# BGA TECHNICAL COMMITTEE

## TECHNICAL NEWSHEET 9/10/99

AS W 20 FL  
Rudder Pedal Failure

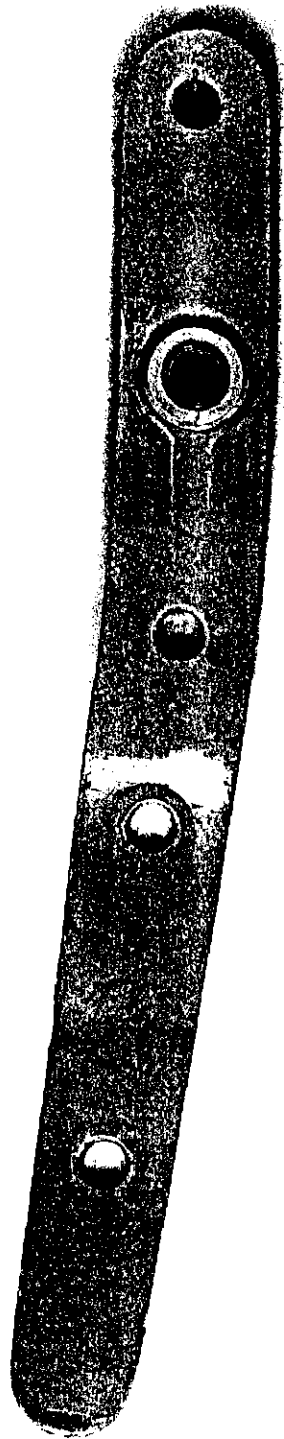
- 1.11.     **ASW 20FL - RUDDER PEDAL FAILURE IN FLIGHT.** Sketch from Colin Short identifies the failure. Inspect a.s.a.p.
- 2.0.     **GENRAL MATTERS**

DEFINITELY NOT TO SCALE!
